S-Comm Technologies Pty. Ltd.

Technical response to the ACMA consultation on the Queensland DRCP

for
EON Broadcasters

Figure 2-11: Comparison of antenna patterns

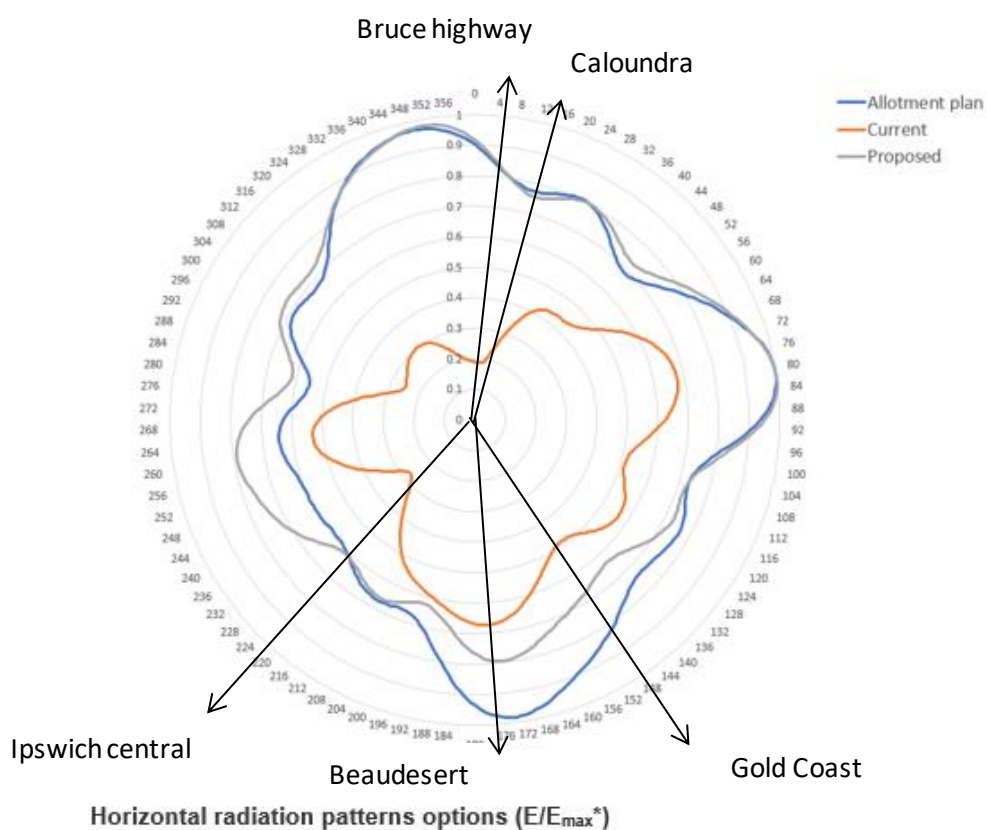
The proposed technical specifications are shown in Table 2-2. This specification includes the complete removal of the northern notch in the HRP and the power increase to 50 kW ERP. The resulting antenna HRP is shown in Figure 2-11 as the grey trace.

The area of primary concern is the sector 350° to 20° and more specifically the sector 5° to 15° which covers the area from the Bruce Highway east to the coast and covers the majority of the licence area population and residential growth areas. Given that the increase in field strength is expected to be

around 10 -13 dB and a 10 dB increase on the vector 340° will allow Mt Mee to reach full operating power we propose that the HRP in the northern east sector be reduced in power by at least 4 dB.

EON propose that an antenna pattern similar to the Alt-1 HRP shown in Figure 3-5 which limits the power to the sector 10-20 by 6 dB coupled with the rotation of the Mt Mee antenna by 90 clockwise will provide significantly reduced overspill into the Nambour only area. We refer to this combination as the Alt-1C proposal. Note this includes an ERP from Mt Coot-tha of 50 kW and uses the current VRP.

Figure 2-14: Coverage from Mt Coot-tha at 50 kW proposed HRP with Mt Mee at 500W – northern area

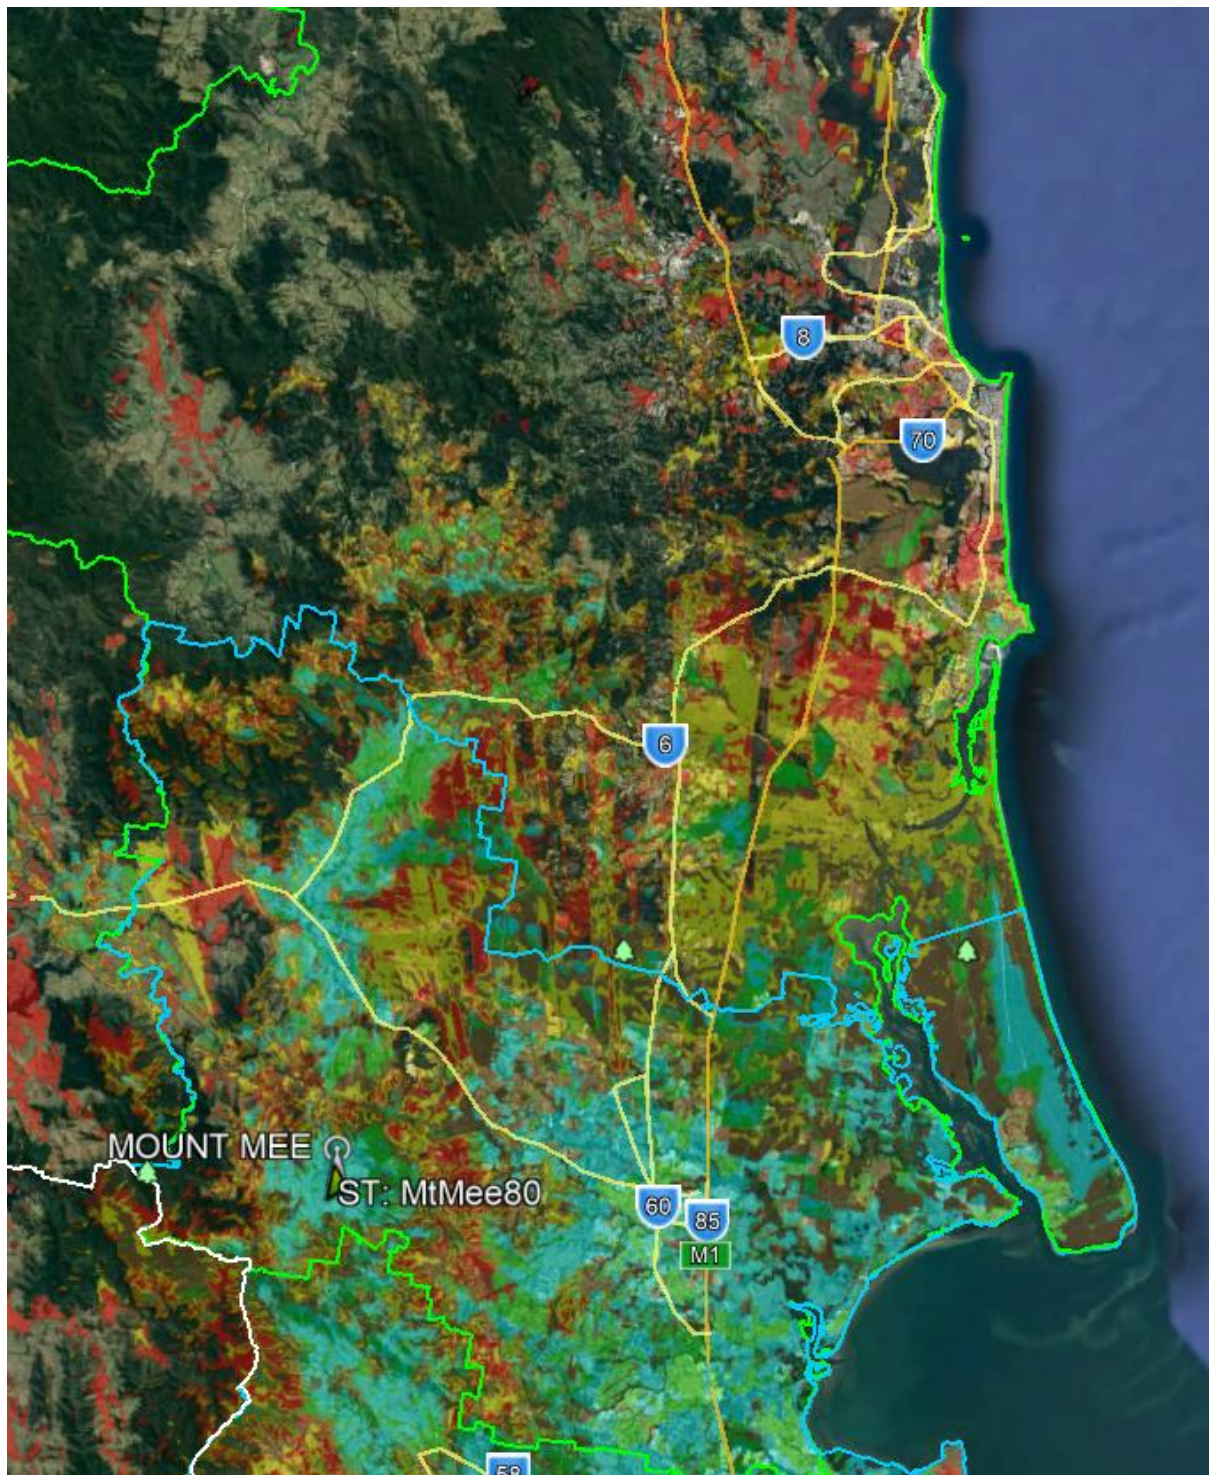
As shown in Figure 2-14 the coverage of the Caboolture shire area (the Nambour RA1 and Brisbane RA1 overlap area) is increased significantly to allow the Brisbane Broadcasters to cover that portion of their licence area. Much of the populated area coverage has been increased to Dense Urban grade, i.e. > 70 dBuV/m.

Figure 2-15: Expected composite coverage – Mt Coot-tha at 50 kW proposed HRP and Mt Mee at 0.5 kW – in Nambour only

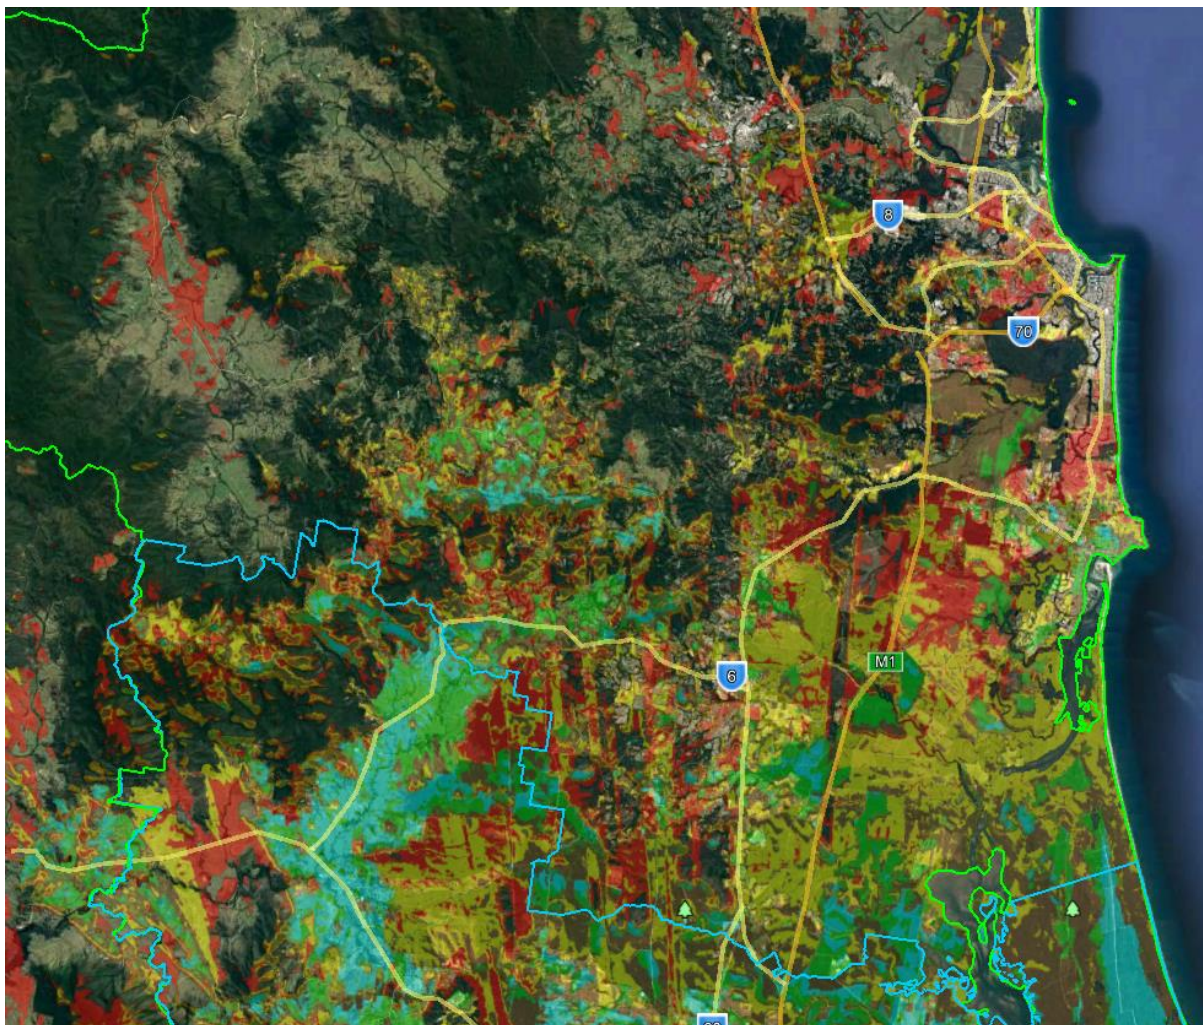
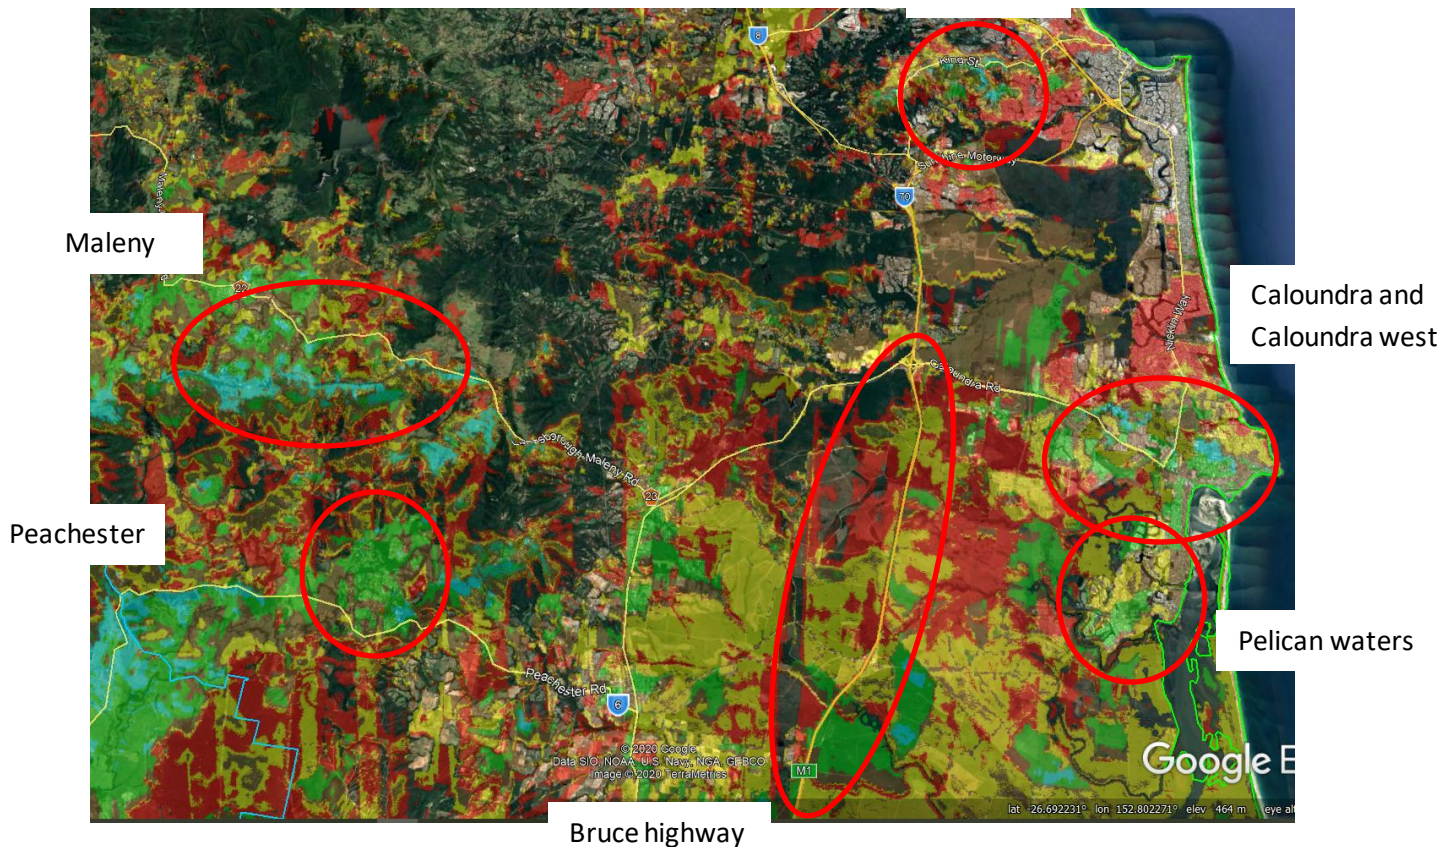
Observing Figure 2-15 and Figure 2-16 we see that the coverage of the Nambour only area has also increased significantly and in some cases excessively. In particular we see highlighted in Figure 2-16 that some high population centres in Nambour have areas of coverage in excess of 70 dBuV/m as well as larger areas of urban grade >60 dBuV/m including Caloundra, the expanding areas of Caloundra west, Golden beach and Pelican waters, as well as the ridge in Buderim and the towns of Maleny and Peachester. Also, the Bruce highway has uninterrupted coverage from the northern boundary of the Brisbane RA1 licence area to the Caloundra road turn off 24 km to the north.

Figure 3-1: Mt Mee HRP at current bearing of 80°T (left) and with bearing of 170°T (right) (dB scale)

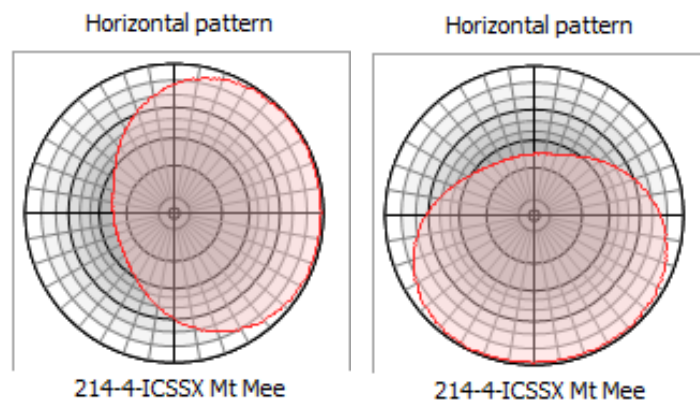
Rotating the current broad beamwidth antenna by 90° clockwise to a bearing of 170°T will significantly reduce the power transmitted to the north east and reduce overspill into Nambour. The power towards Caloundra will be reduced by around 6 dB.

Figure 3-2: Coverage from Mt Mee HRP at current bearing of 80°T (left) and with bearing of 170°T (right)

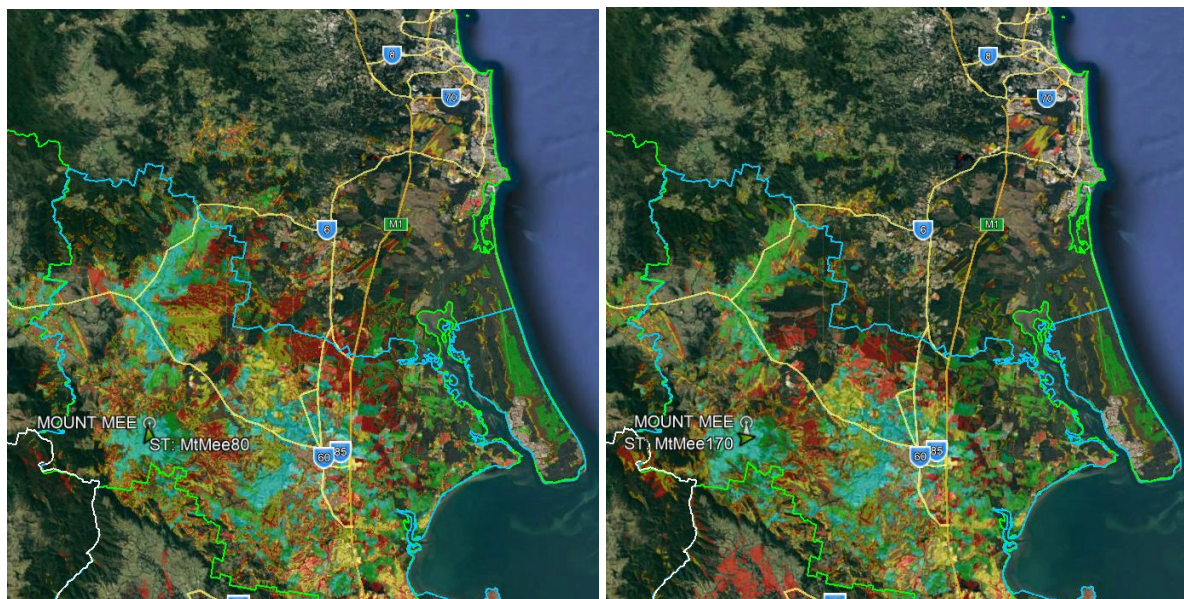
The coverage from Mt Mee is compared in Figure 3-2. Caboolture shire has very similar coverage while there is less overspill into the Maleny ridge and Caloundra. The D'Aguilar highway and Woodford areas retain good coverage.

Figure 3-3: Mt Mee HRP used for the shadowed antenna option (dB scale)

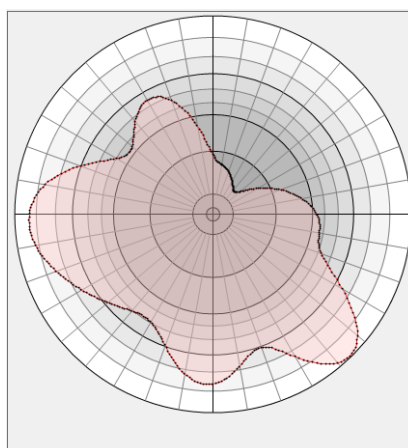
The current antenna may be moved to be below the top of the tower at Mt Mee in a position of approximately the south west leg. The tower will then provide a coverage shadow to the north east sector towards Caloundra reducing coverage in the Nambour only area while still providing coverage to the east and south east sector of Caboolture shire as well as the section to the north of Mt Mee.

The resulting antenna pattern is approximated in the HRP shown in Figure 3-3. This HRP is derived from a similar arrangement used for FM and is indicative of what could be achieved. The VRP has been left the same as the current antenna as shown in Figure 2-4.

Figure 3-4: Coverage provided by the Mt Mee shadowed antenna option

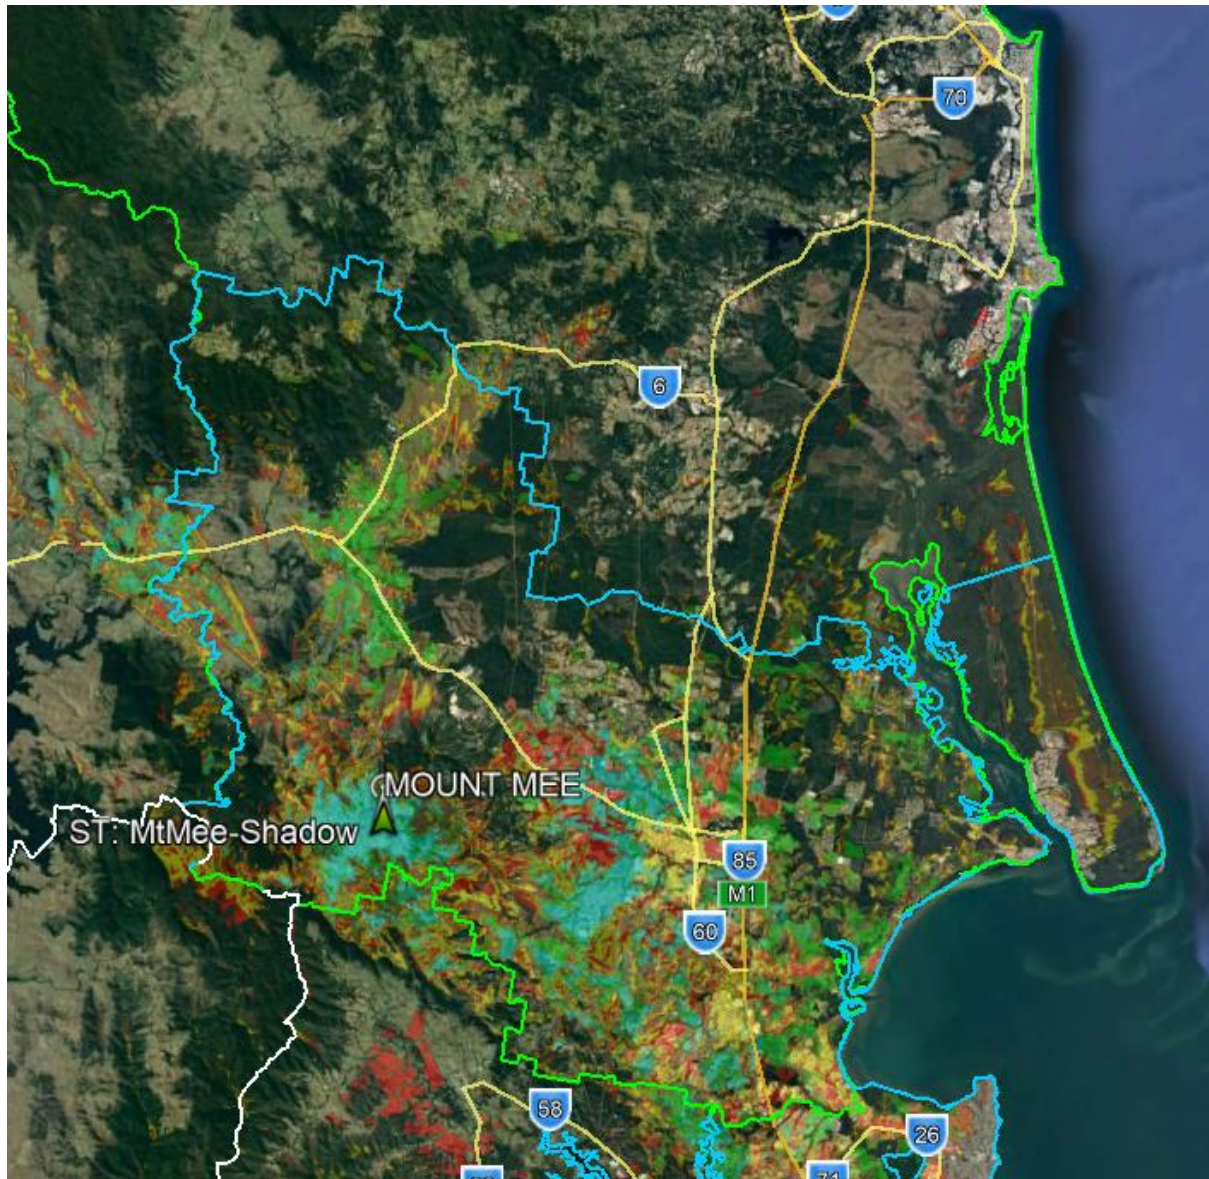
The resulting coverage provided by the shadowed option is shown in Figure 3-4. The resulting coverage provides moderate field strength into the main population area of Caboolture shire and along the main highway but is low in the east around Bribie Island.

The overspill into the Nambour only area is very limited.

Figure 3-5: HRPs for the Alt-1 (left) and ACMA proposed (right) (E/Emax)

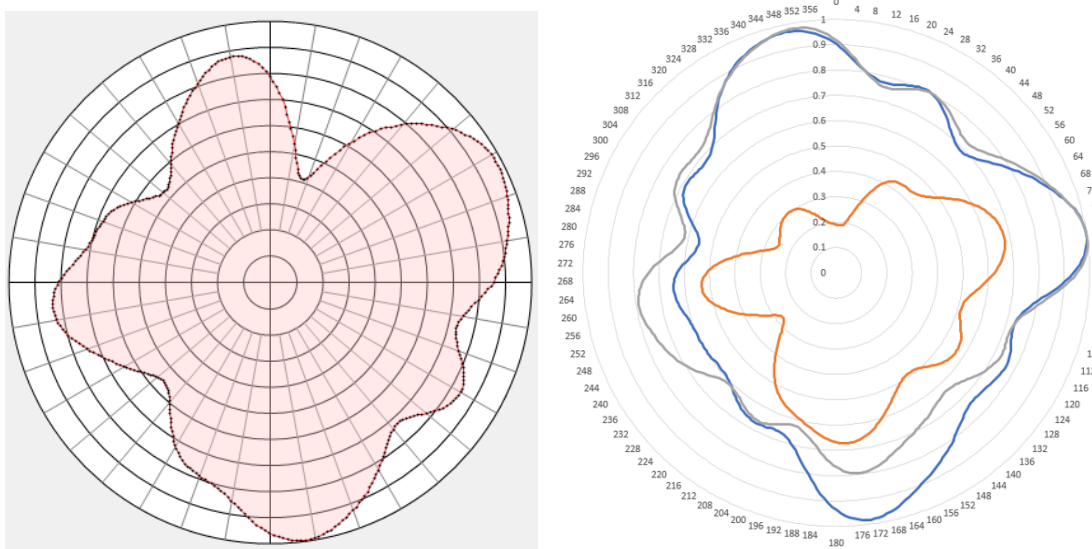
1. This will reduce overspill from the main transmission towards the affected Nambour only areas. The coverage in the Caboolture shire area will be increased by both the Mt Coot-tha and the Mt Mee transmissions.
2. As the proposed specification is expected to increase the field strength received at Mt Mee by over 10 dB a small HRP notch in the sector 5° to 15° should be able to be achieved without significantly impacting the increased gain towards Mt Mee.
3. The depression angle to the northern boundary on the Brisbane licence area towards Caloundra is 0.3° which corresponds to a VRP loss of approximately 0.76 dB.
4. A proposed alternative HRP (Alt-1) is shown in Figure 3-5.

Note that this proposed HRP was produced by Radio Frequency Systems (RFS). Ideally EON would prefer the proposed north eastern notch to be from 5° - 20°T however discussions with RFS indicate that moving the notch further west will impact the power in the direction of Mt Mee. In the spirit of compromise EON have not at this stage proposed to move the notch shown in Figure 3-5 further to the west.
